# WARRANTY BULLETIN

Subject: **Oil Sweating from SE6 Clutch Cover HCM Connector**

No. **2015-1**

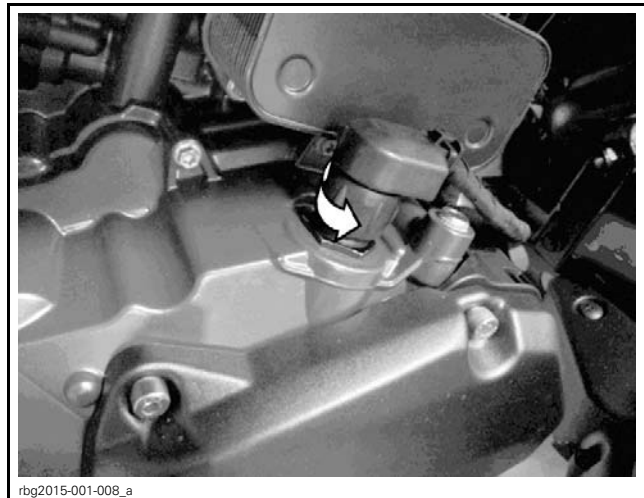
The HCM wiring harness nut on top of the SE6 clutch cover may not have been properly tightened during assembly. This may lead to oil sweating past the o-ring.

Tighten the HCM wiring harness nut to specification. See *PROCEDURE* in this bulletin.

TIGHTENING TORQUE	
Wiring harness nut	5 N•m ± 0.6 N•m (44 lbf•in ± 5 lbf•in)
